**BID ADDENDUM NO. 2**

Date of Addendum: January 27, 2023  
Issued for Bid Date: January 3, 2022 (Bid Opening February 7, 2023)  
Client Name: Eastchester Union Free School District  
Project Name: 2022 Capital Bond Project, Phase 2  
SED Project No.: Waverly School: 66-03-01-03-0-002-011  
Greenvale Elementary School: 66-03-01-03-0-006-015  
Anne Hutchinson Elementary School: 66-03-01-03-0-001-022  
Eastchester Middle / High School: 66-03-01-03-0-003-030 / 66-03-01-03-0-003-029  
MEMASI Project No.: 102-2202  
Contracts: Contract No. 1 – General Construction (GC)  
Contract No. 2 – Mechanical Construction (MC)  
Contract No. 3 – Electrical Construction (EC)  
Contract No. 4 – Window Construction Work (WC)

From dwg. HS AD101

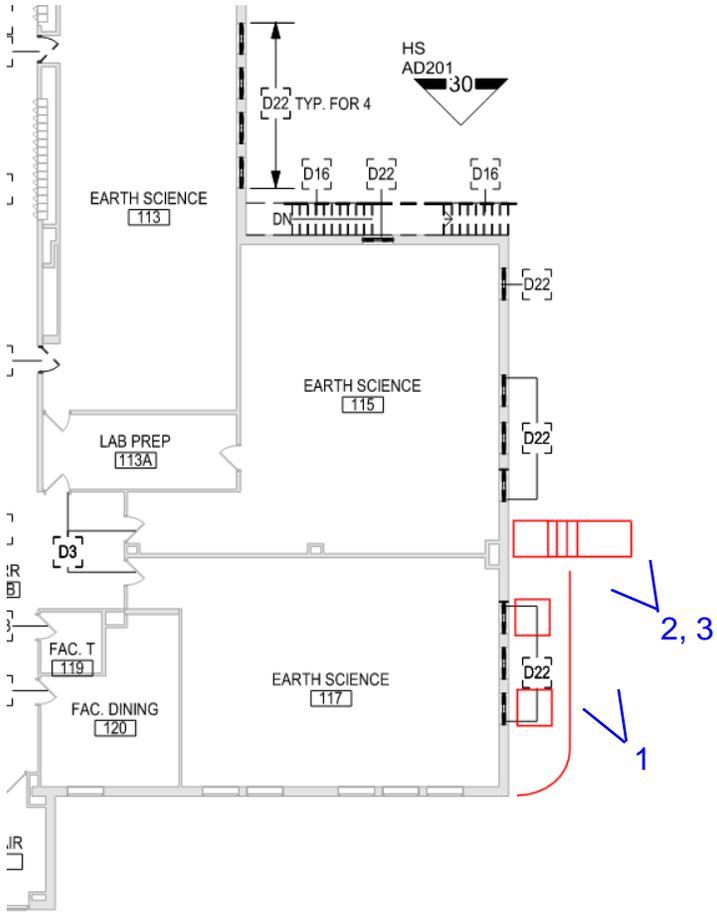
- 1) HS Elevation drawing HS-A203 uses LEGEND Code "RL" for replacement of Lintel . Please confirm that the only lintels to be removed are those indicated by "RL" and have been identified on drawing H-011 as having Waterproofing Tar.
- 2) Drawing HS-A203 indicated to "Remove Slab and Replace Curb" Please clarify this scope of work. It is not clear the square footage of the slab designated for replacement. It is assumed the curb is the length of wall indicated.

STEAM COIL PIPING DETAIL

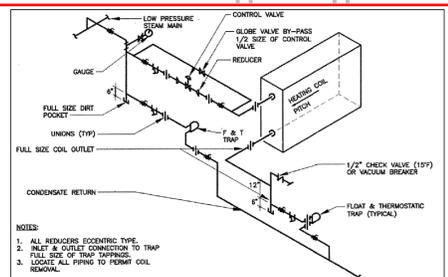
Can a piping detail for the steam cabinet unit heaters FCU-GR-1 & 2 be provided

See steam coil piping detail on drawing GR M301, also shown here for reference.

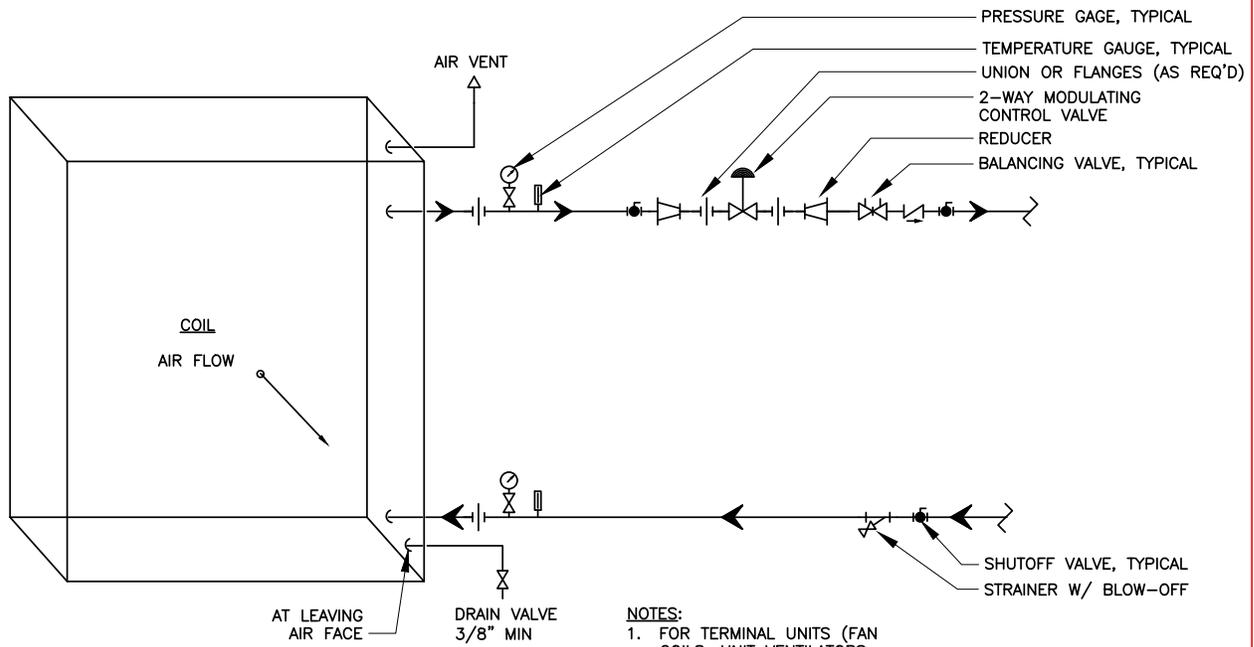
Please provide us with pipe size of steam and condensate pipe where we are tying in for new piping to FCU3 Also we are being instructed to run new chilled water S & R from new FRCU 3 to tunnel and cap for future. Are we connecting to coil? If so provide a coil pipe detail. Please advise.

Contractor to field verify steam and condensate return main sizes in tunnel after commencement of construction and removal of pipe insulation. Contractor's bid to account for new connections.  
New dual-temperature hot/chilled water piping shall be provided from FCU-GR-3 to tunnel as indicated on the drawing, and capped for future. Insulation must be suitable for both hot and chilled water duty.  
Provide chilled water piping at FCU-GR-3 as per detail on the following page.
